DESCRIPTIVE REPORT

Type of Survey Hydrographic
Field No. FA-10-6-85
Registery No. H-10203

State Alaska
General Locality Kelp Bay
Sublocality Portage and Middle Arms

PACIFIC MARINE CENTER
EVALUATION REPORT
H-10203

CHART
17337
1:40,000

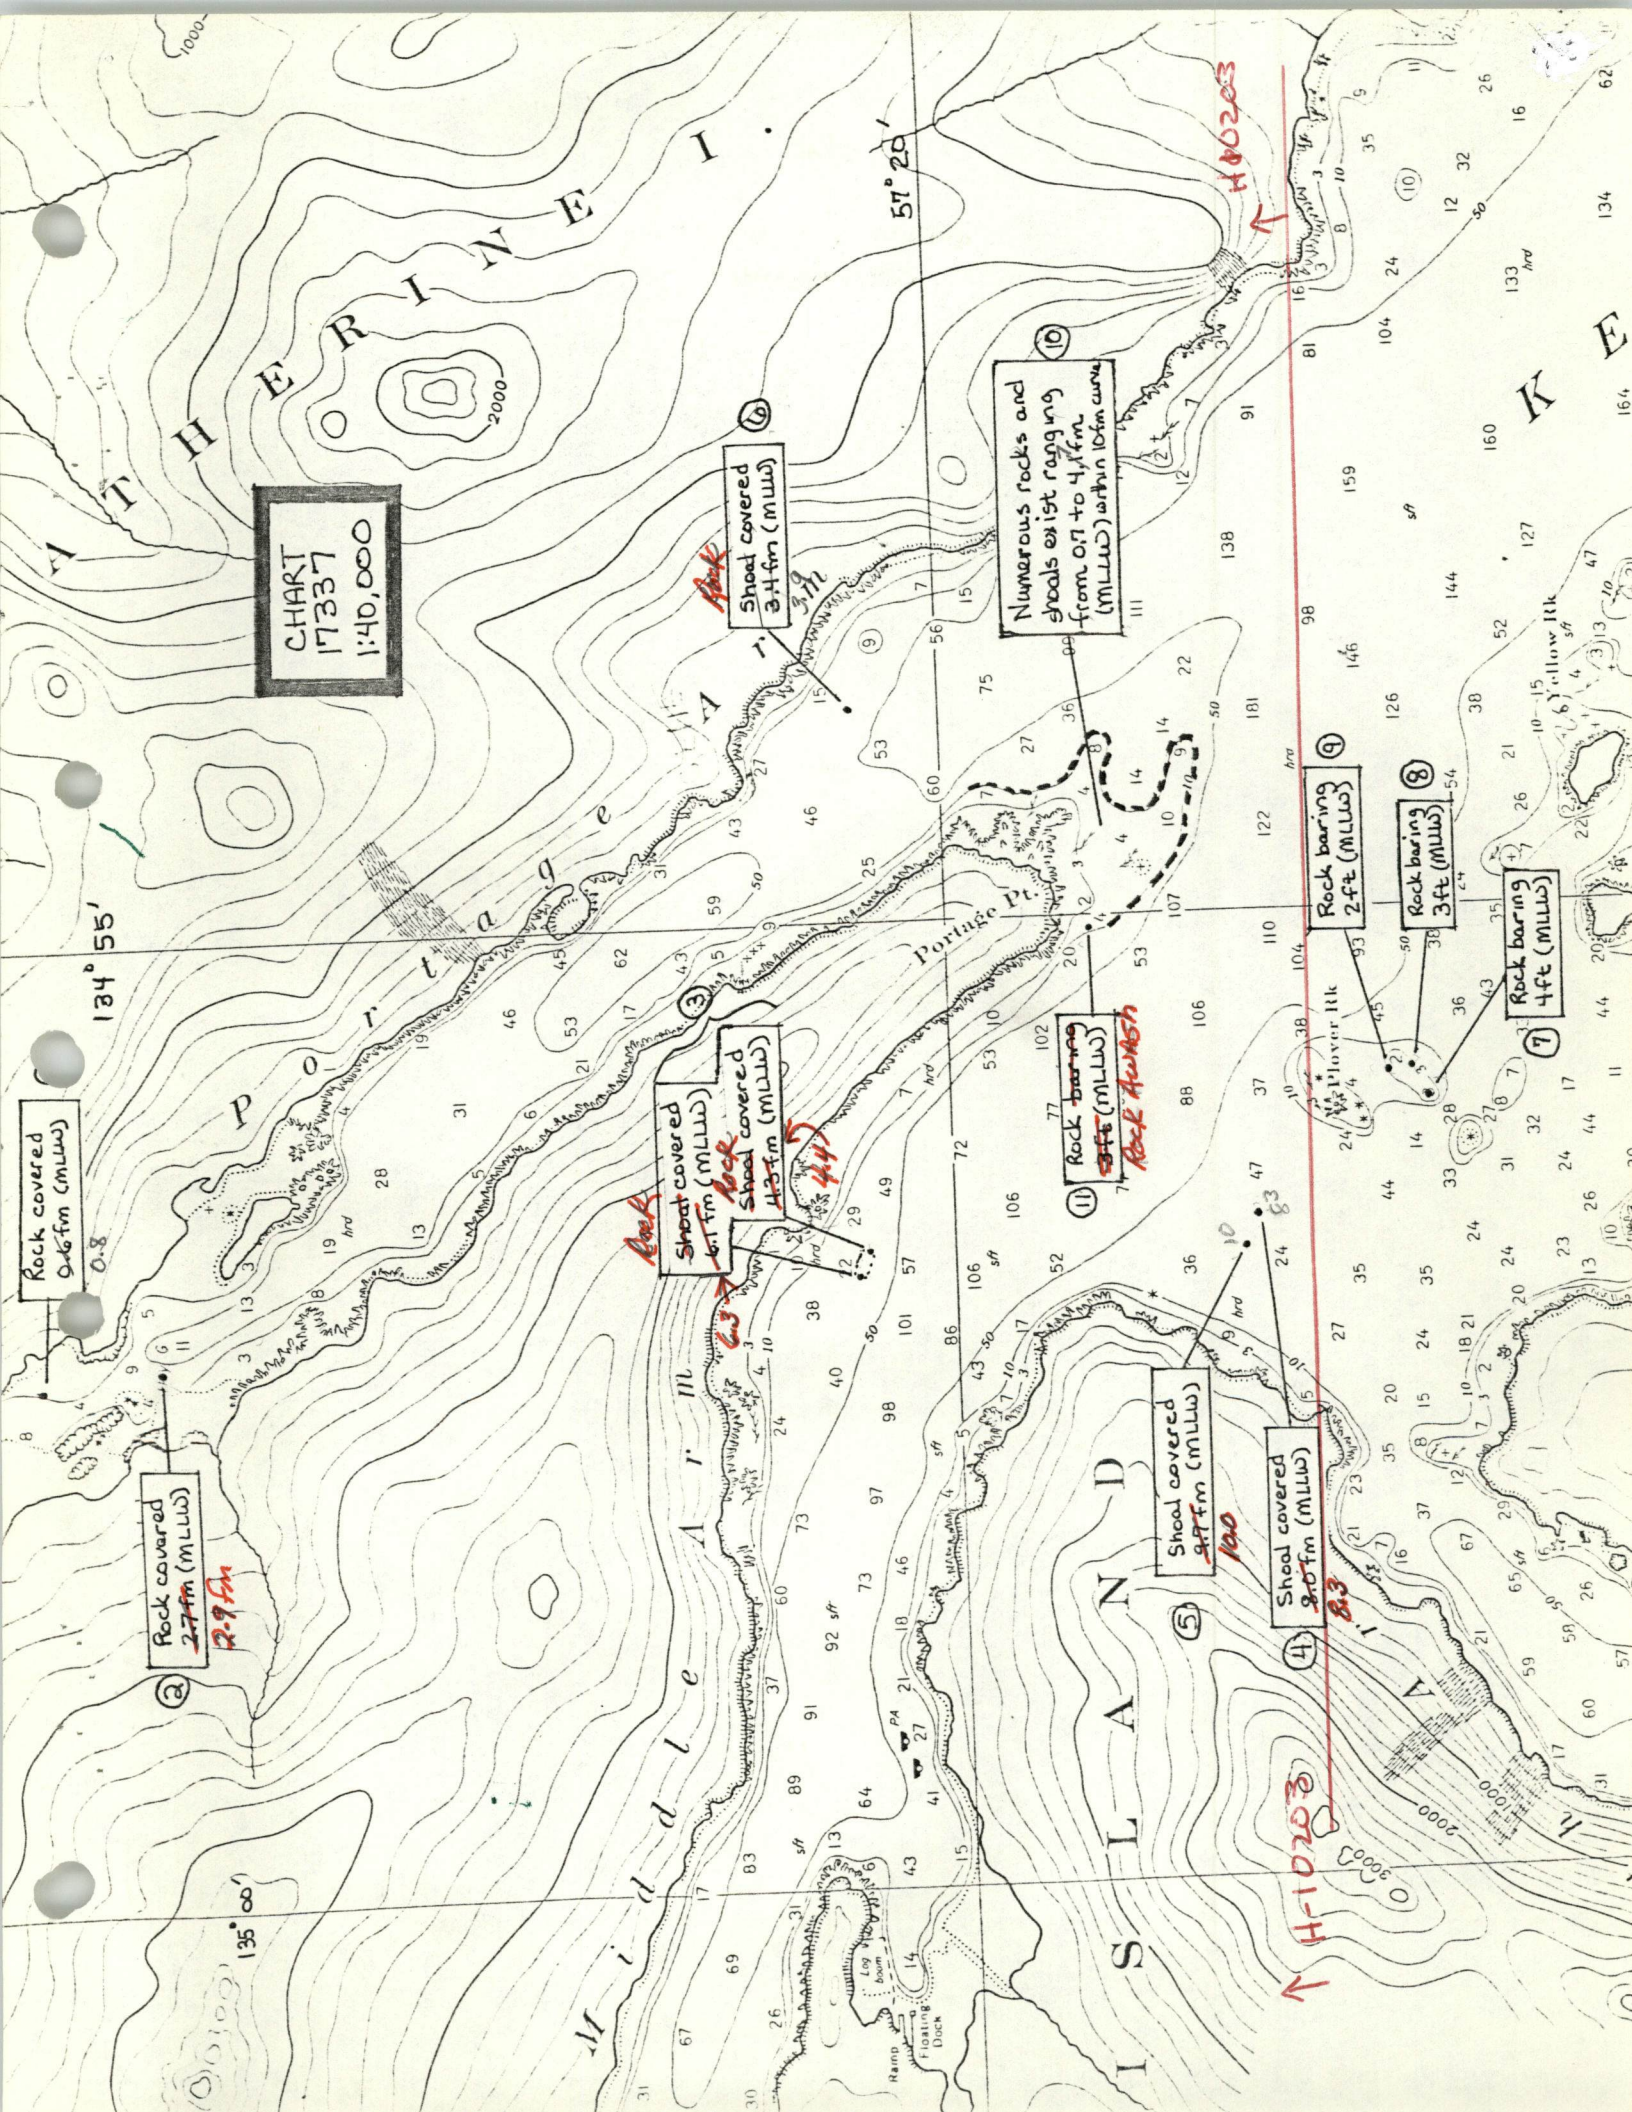
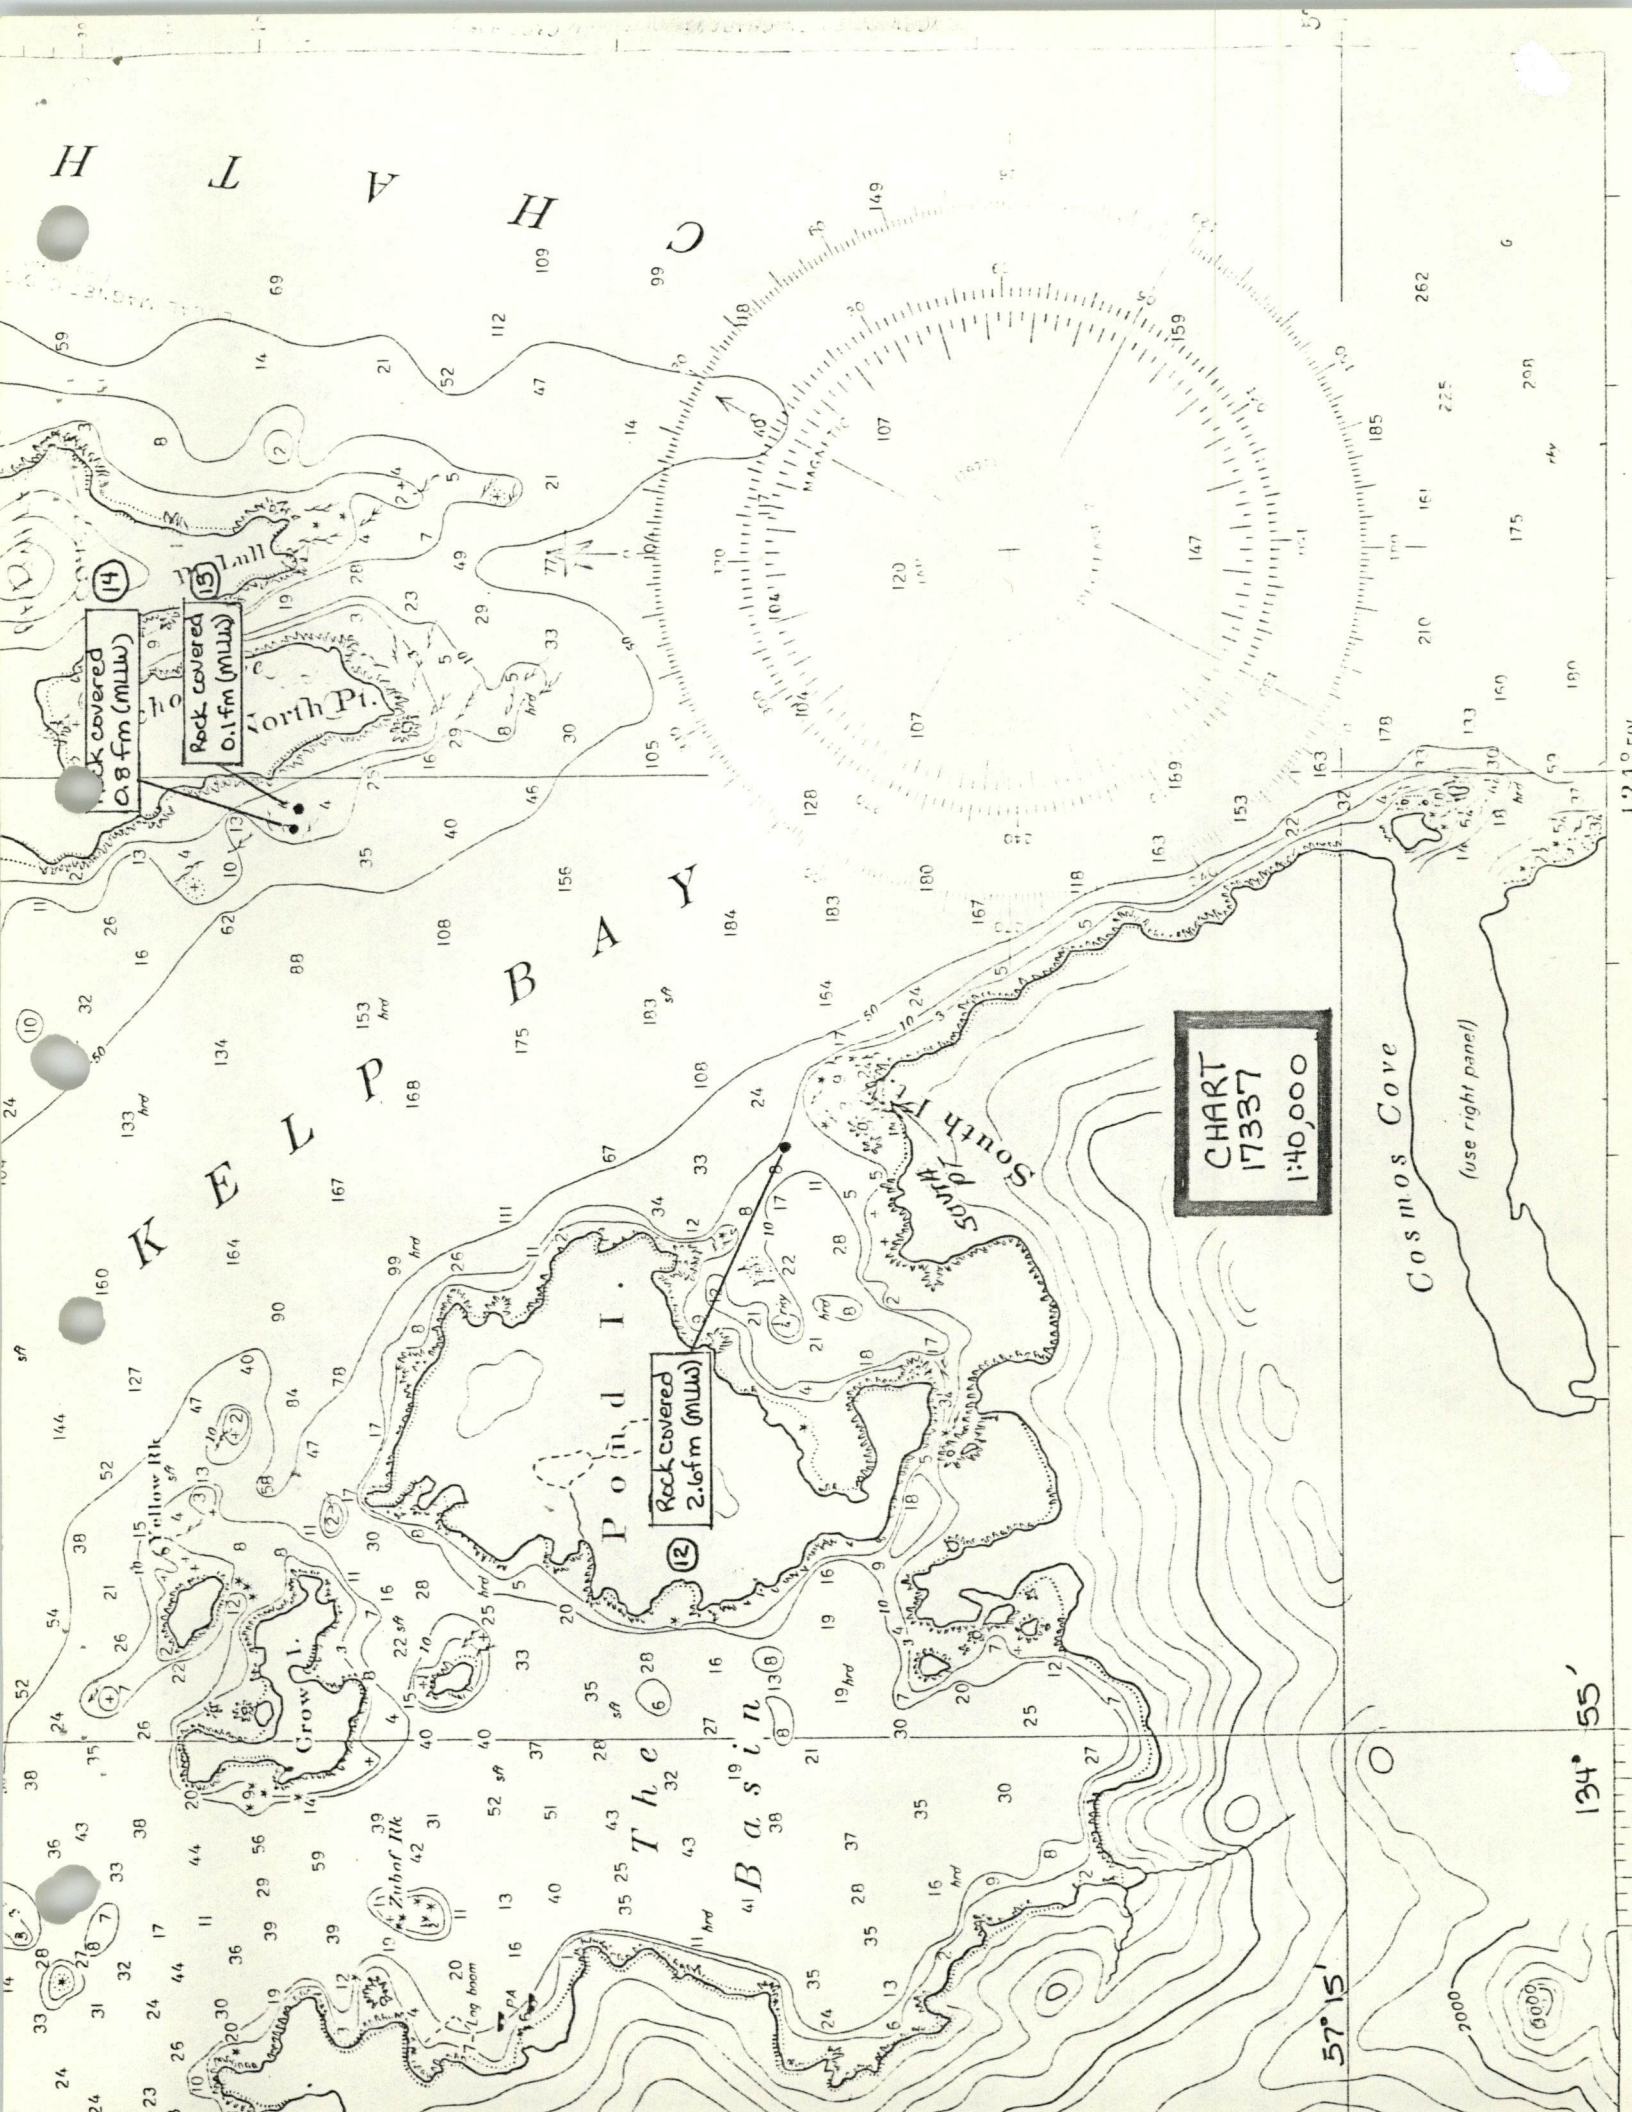
Rock covered
0.6 fm (MLWS)

Rock covered
2.7 fm (MLWS)
2.9 fm

Shoal covered
6.1 fm (MLWS)
Rock
4.3 fm (MLWS)
4.4

Shoal covered
3.4 fm (MLWS)
Rock

Rock baring
3.4 fm (MLWS)
Rock hatched

Shoal covered
9.0 fm (MLWS)
100

Shoal covered
9.0 fm (MLWS)
8.3

Rock baring
2 ft (MLWS)

Rock baring
3 ft (MLWS)

Rock baring
4 ft (MLWS)

Numerous rocks and
shoals exist ranging
from 0.7 to 4.1 fm
(MLWS) within 10 km area
